Re: Preliminary Foundation Recommendations
Proposed Grade Raise, Northwest Bay Crossing
W.P. 89-86-01, Str. Site 43-57
Highway No. 64, District 54, Sudbury

Subject: Highway 64
W.P. 89-86-01, Site No. 43-57
Causeway Realignment and
Structure Rehabilitation at Lavigne
District 54, Sudbury

Re: Causeway Realignment and
Structure Rehabilitation at
Lavigne, Hwy. 64
W.P. 89-86-01, Site 43-57
District 13, North Bay

RE: WEST BAY OF LAKE NIPISSING AT LAVIGNE
W.P. 86-86-01 SITE 43-57
HIGHWAY 64

FIG -1
WP 89-86-01

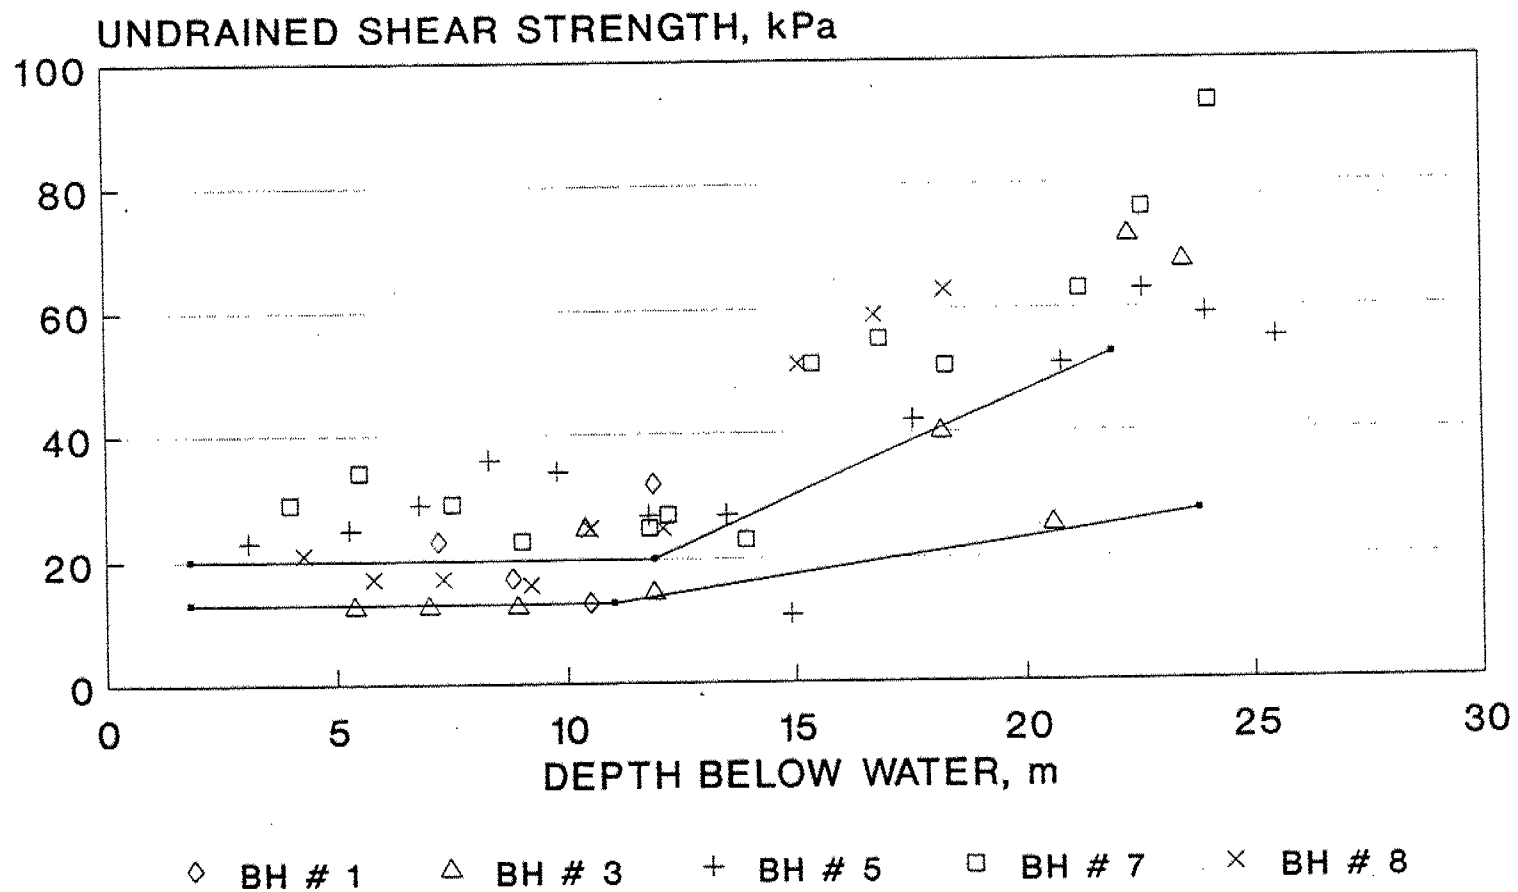
The variation of undrained shear strength versus elevation (plotted as depth below water level) is shown on Figure 1. The vane shear strength values obtained during the recent investigation are shown on this figure. Also included in the figure is the range of shear strength values obtained from the previous investigation included in the Geocon Report. No well defined trend could be seen in the change in shear strength over the last 30 years or so. Some increase in shear strength appears to have occurred in the area of boreholes 5 and 7, whereas in boreholes 1, 3 and 8, the average shear strength at shallow depths remained practically the same.

PROPOSED EMBANKMENT WIDENING
TYPICAL DETAIL

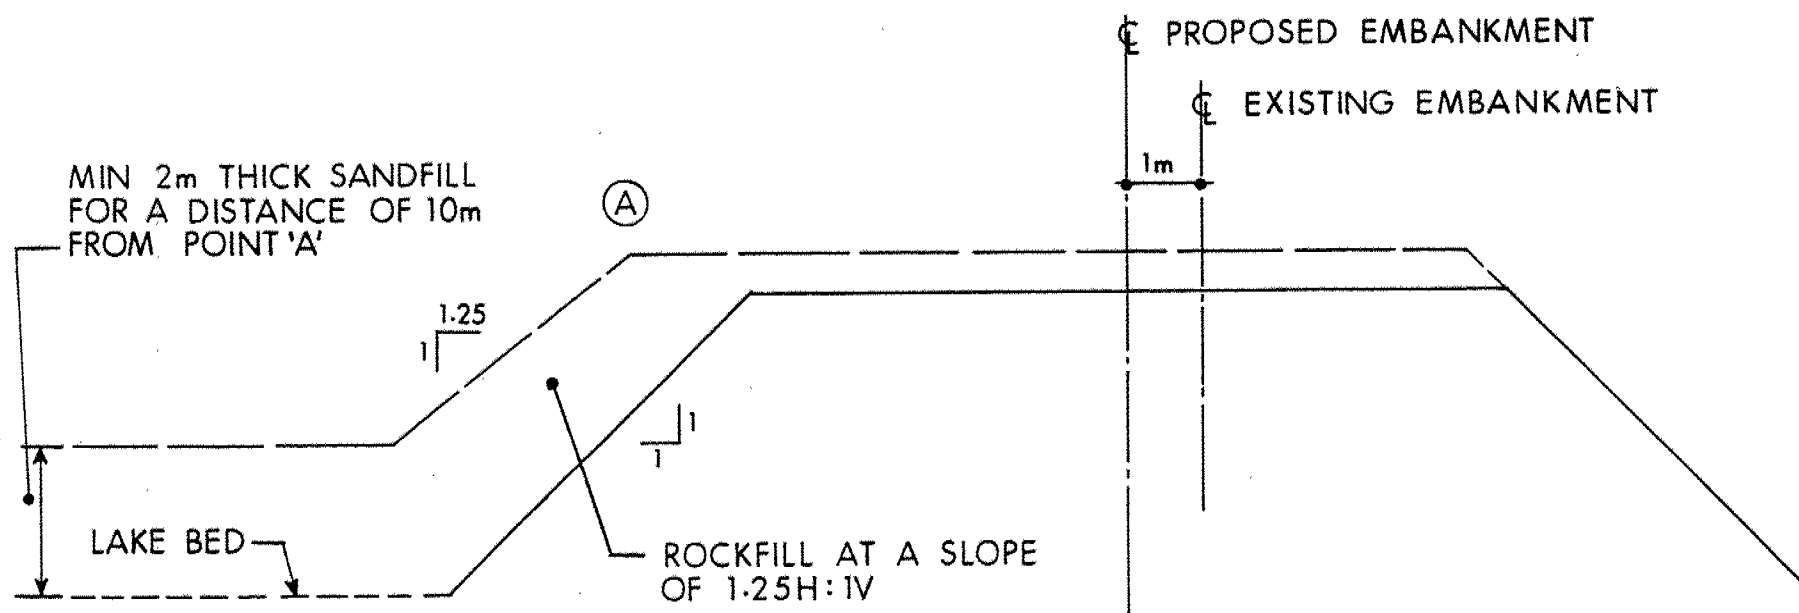
As mentioned earlier in this memo, it is understood that the centre line of the highway embankment would be a maximum of 5 m above the lake bed and that it would be shifted 1 m to the west of the present location. The proposed construction details are shown on the attached sketch. (See Figure 2)
